South Texas Project
Units 1 & 2
Docket Nos. STN 50-498, STN 50-499
First Set of Responses to April 11, 2016 Requests for Additional Information
Regarding STP Risk-Informed GSI-191 Licensing Application
(TAC NOs MF2400 and MF2401)

Follow-up RAI 18 – NON-PROPRIETARY VERSION

Attachment 2
Response to SSIB-3-1 through 3

Figure 1: Upper Steam Generator Compartment Fluid Exit Paths

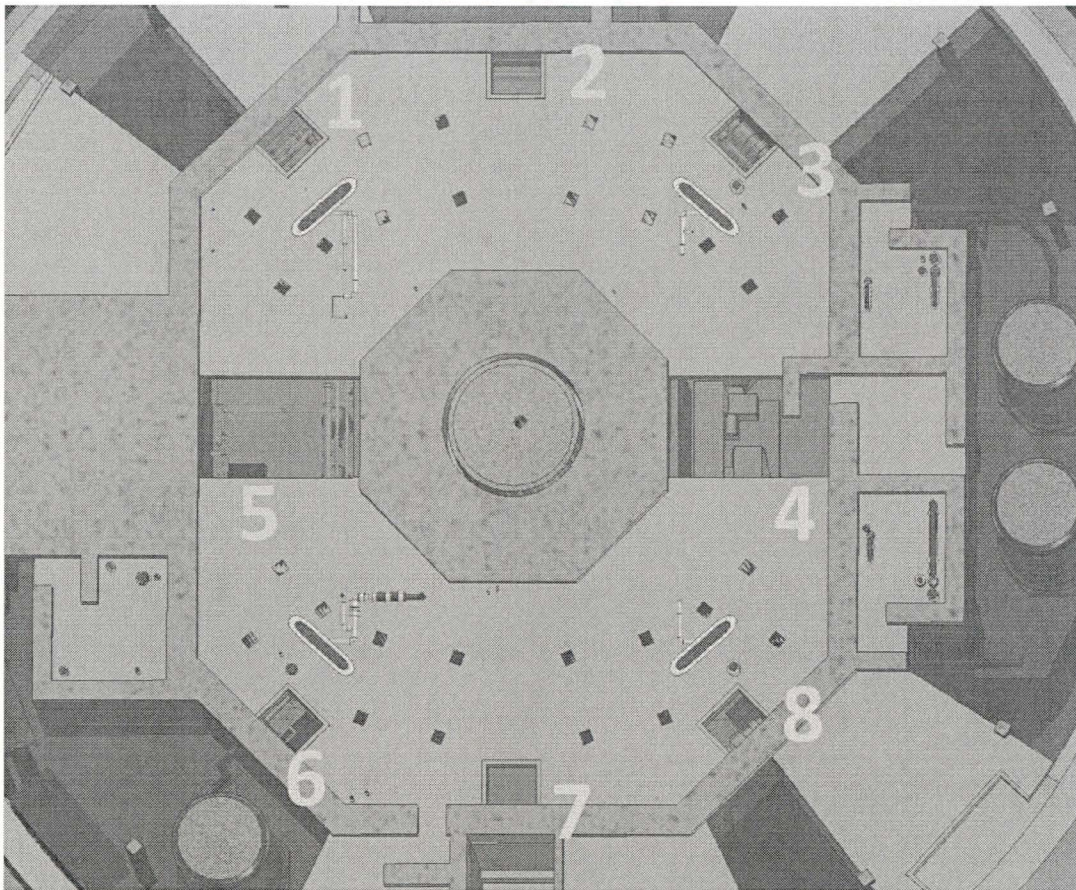
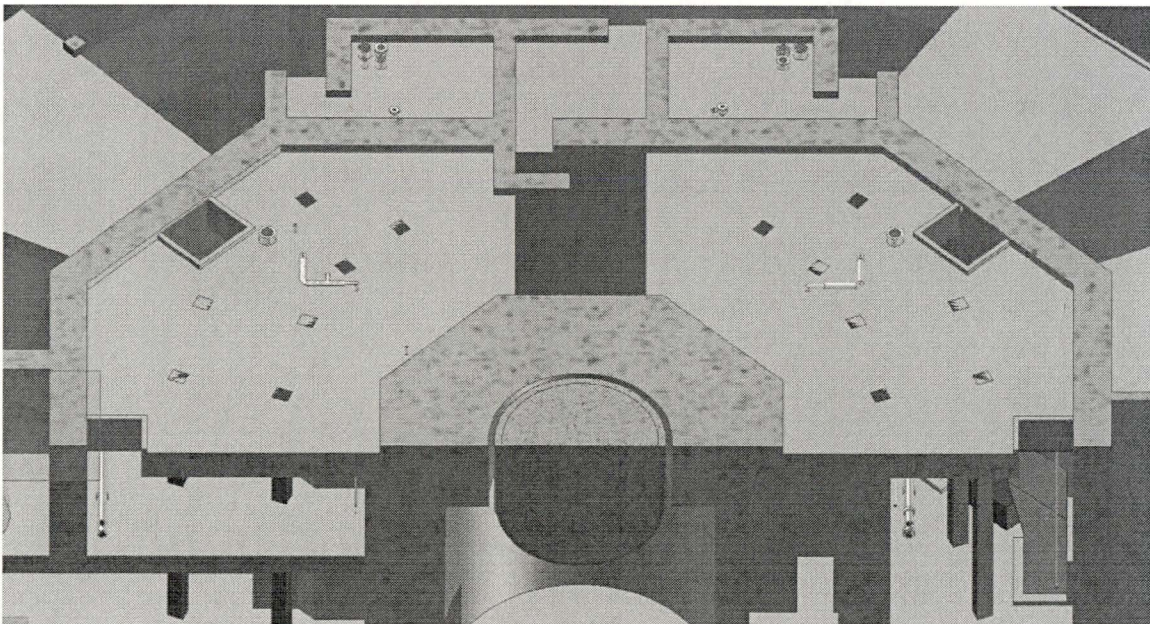
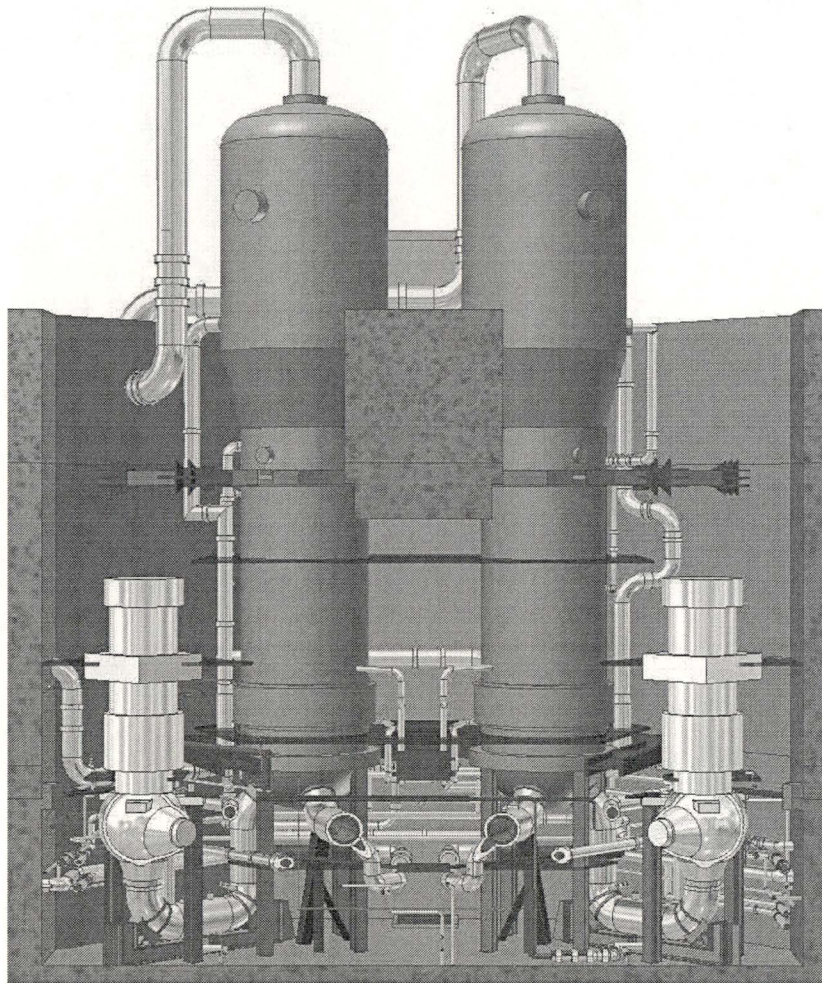
Based on NRC staff's review of the RoverD submittal, it appears that large pieces of debris do not reach the sump pool since they are eroded at 1 percent, as would be expected for debris held up on gratings. Please confirm that large pieces of debris do not reach the pool, and provide details on what prevents any large pieces from falling into the pool.

The evaluation described below confirms that a large piece LDFG in the limiting debris transport break location used in the RoverD submittal will be 100% held up (aside from erosion) in the steam generator compartment and 0% percent transport to the pool. A LBLOCA situated within the steam generator compartment produced the highest debris total transport fractions while still representing all but a small number of low debris generation breaks, (that is, those in the compartment below the generator compartment). These transport fractions, representing transport from the steam generator compartment, were applied to all breaks as a reasonably conservative assumption.

The steam generator compartment LBLOCA transport fraction for large pieces of LDFG was zero [1]. This is due to the tortuous path debris must traverse in order to reach the containment pool. The floor of the steam generator compartment is shown in Figure 1 and Figure 2. The only potential downward exits for fluid are through the 8 grated floor panels indexed in Figure 1.

Additionally Figure 3 has been provided to show the vertical constraints on debris caused by the SG compartment walls.

Large piece LDFG was conservatively assumed to be the smallest possible size of the category: 6" pieces. These pieces are of a size which is incapable of passing through a grating like those which cover the downward fluid exit paths of the compartment. The Drywell Debris Transport study [2] classified these fiber debris sizes in Table 1 where large piece LDFG present at STP is comparable to the DDTS classification of the same name. Due to this nature of the plant construction and large piece debris characteristics it is reasonable and appropriate to conclude that all large piece LDFG are trapped within the SG compartment on concrete and gratings, and fail to transport to the containment pool.
